Contract No. T201007405.01  
Federal Aid Project No. EBHN-2010(29)  
BRS 1-687, 1-688, 1-693 SOUTH WALNUT ST. SOUTH MARKET ST.  
New Castle County

Enclosed is Addendum No. 2 for the referenced contract consisting of the following:

|  <b>DELAWARE<br/>DEPARTMENT OF TRANSPORTATION</b> | ADDENDUMS / REVISIONS |  | SCALE AS NOTED | BR 1-687, 1-688, 1-693; SOUTH WALNUT STREET, SOUTH MARKET STREET AND FOURTH STREET OVER CHRISTINA RIVER | CONTRACT   | BRIDGE NO.   | 1-687 | SITE NOTES | SHEET NO.   |

**BRIDGE 1-687 NOTES**

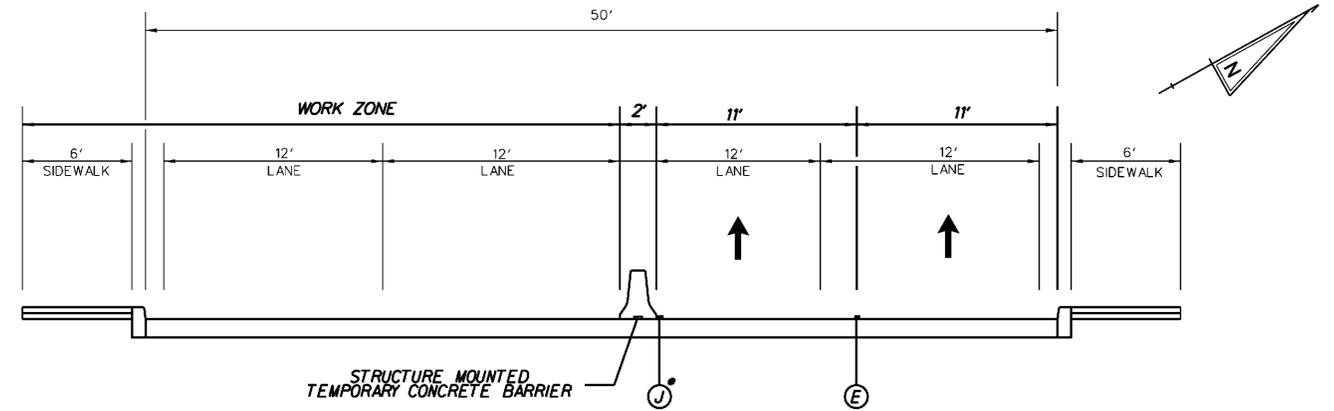
**Items 605533 and item 605619 are the correct items (LS payment). Revisions have been made to Sheets 3, 4, 6 and 67 to correct this. The Special Provisions are correct.**

9. Note 5 on sheet 6 indicates the Pier 2N diaphragm replacements are paid under Item 605585. This item has a breakout sheet that does not include this work. Please advise where we are to put the cost of this work.

10. It would seem that you need another Breakdown Item for Item 605585 Steel Structure Repair. Note #5 on Sheet 6 of 111 for Bridge 1-687 (Walnut St.) requires the replacement of Diaphragms at Pier 2N. We do not have a problem with the work to be performed, but there is no breakdown item for this work on the Breakout Sheet. Could you please add an Item No. 4 for this work.

5. REMOVE AND REPLACE THE DIAPHRAGMS AT PIER 2N AS INDICATED IN THE PLAN DETAILS. PROVIDE ADEQUATE BRACING TO ASSURE STABILITY OF THE EXISTING GIRDERS DURING REMOVAL AND ERECTION OPERATIONS. STEEL MEMBERS SHALL CONFORM TO AASHTO M270 GRADE 36 OR GRADE 50. PAYMENT FOR FABRICATION AND ERECTION OF NEW STEEL SHALL BE UNDER ITEM 605585. REMOVAL OF EXISTING STEEL SHALL BE PAID UNDER ITEM 211000.

6. APPLY WATER BASED ACRYLIC CONCRETE SEALANT TO THE SIDEWALK FACE NORTH WINGWALL BARRIERS. PAYMENT SHALL BE UNDER ITEM 602518.
7. REPLACE ALL EXISTING NEOPRENE STRIP SEALS AT THE SOUTH AND NORTH ABUTMENT AND PIER IS & IN. PAYMENT SHALL BE UNDER ITEM 605658. BLAST CLEAN THE EXISTING STEEL JOINT ARMOR TO REMOVE ALL RUST, LOOSE PAINT, DIRT, OIL, DEBRIS & DELAMINATION. ALL EXPOSED JOINT ARMOR SURFACES SHALL BE FIELD PAINTED IN ACCORDANCE WITH SECTION 605 OF THE STANDARD SPECIFICATIONS. PAYMENT FOR CLEANING & PAINTING SHALL BE UNDER ITEMS ~~605629~~ AND ~~605629~~ 605619 AND 605533.

8. CLEAN, PAINT AND APPLY GREASE TO BRIDGE BEARINGS. FOR BEARINGS WITH VISIBLE CORROSION, REMOVE EXISTING PAINT, AND PREPARE SURFACE PRIOR TO APPLICATION OF NEW PAINT COATINGS. PAYMENT SHALL BE UNDER ITEMS ~~605629~~ 605533 AND ~~605629~~ 605619. APPLY GREASE TO NEWLY PAINTED BEARINGS. SPECIFICATIONS FOR GREASE SHALL COMPLY WITH PROJECT NOTES FOR THIS CONTRACT. APPLICATION OF GREASE FOR REPAINTED BEARINGS SHALL BE INCIDENTAL TO ITEM ~~605629~~ 605619. FOR REMAINING BEARINGS NOT TO BE RE-COATED WITH PAINT, APPLY GREASE TO BEARINGS. PAYMENT SHALL BE INCIDENTAL TO ITEM 605636. PRIOR TO APPLICATION OF GREASE, PREPARE BEARING SURFACE FOR APPLICATION AS REQUIRED FOR PROPER ADHERENCE OF THE GREASE, AND AS APPROVED BY THE DELDOT INSPECTOR. USE LOW PRESSURE WATER BLASTING TO REMOVE EXISTING DEBRIS. HAND WIPE TO REMOVE EXISTING DEBRIS IN LOCATIONS APPROVED BY THE DELDOT INSPECTOR. AVOID DAMAGE TO EXISTING PAINT COATING BY USING LOW PRESSURE WATER BLASTING SUFFICIENT TO REMOVE EXISTING DEBRIS AND CONTAMINANTS. GREASE SHALL BE APPLIED TO ALL BEARINGS ON BRIDGE. ALL DEBRIS ON PIER CAPS AND ABUTMENT BEARING SEATS SHALL BE REMOVED. REMOVAL OF DEBRIS IS INCIDENTAL TO ITEM ~~605629~~ 605533.

11. REPLACE DAMAGED BOTTOM RAIL OF THE STEEL BARRIER. LOCATIONS SHALL BE AS INDICATED IN THE DECK PLANS. STRUCTURAL STEEL TUBING SHALL CONFORM TO ASTM A 500, GRADE B OR ASTM A 501. PAYMENT SHALL BE UNDER ITEM 605585. REMOVAL OF EXISTING BARRIER RAIL SHALL BE PAID UNDER ITEM 211000. CLEAN AND PAINT THE ENTIRE STEEL BRIDGE BARRIER INCLUDING ALL RAILING, POSTS, BASE PLATES AND CONNECTION HARDWARE. CLEAN AND PAINT THE PORTIONS OF THE BASCULE GIRDERS ABOVE THE RIDING SURFACE INCLUDING THE STEEL CURB. PAYMENT FOR CLEANING AND PAINTING SHALL BE UNDER ITEMS ~~605629~~ 605533 AND ~~605629~~ 605519.

**SITE NOTES**

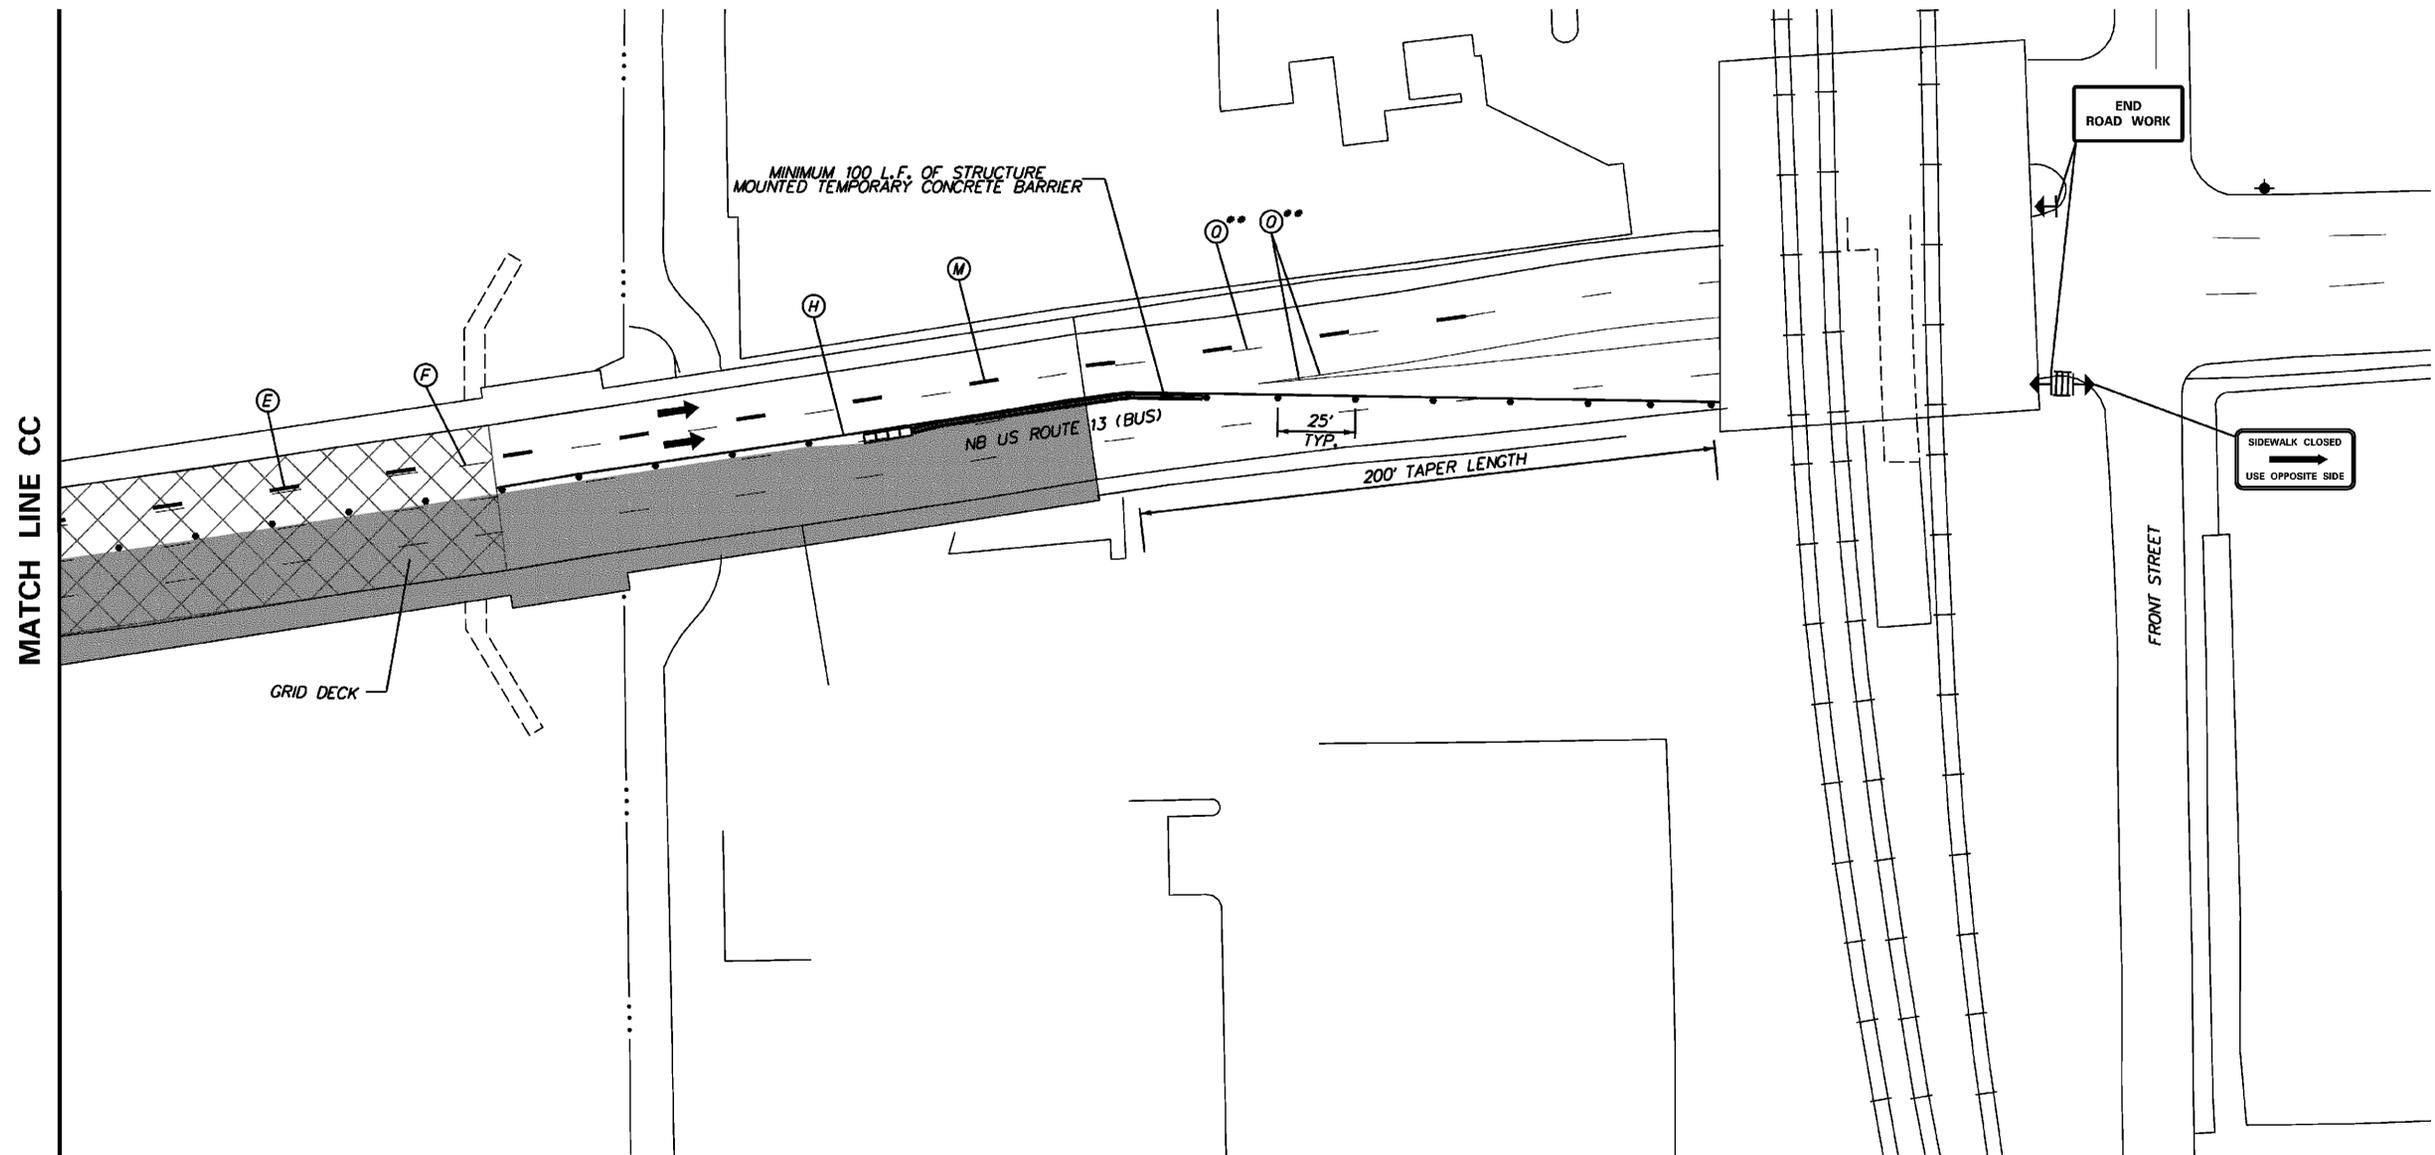
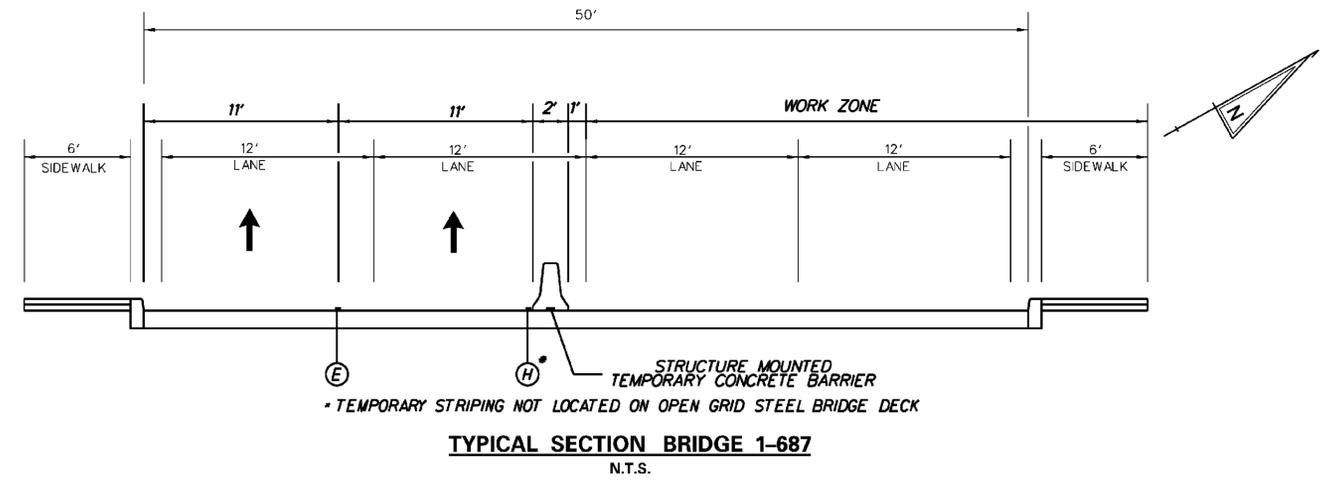
1. I noticed in the plans that sheets 60 and 67 are identical. There is very little information for bridge 688 particularly the bridge notes.

**The Site Notes Sheet shown as sheet 60 is an incorrect sheet and will be replaced by a Phase 2 MOT sheet. Also, Phasing sheets for BR 1-687 are out of sequence and sheets 55-60 will be renumbered to match the correct sequence.**
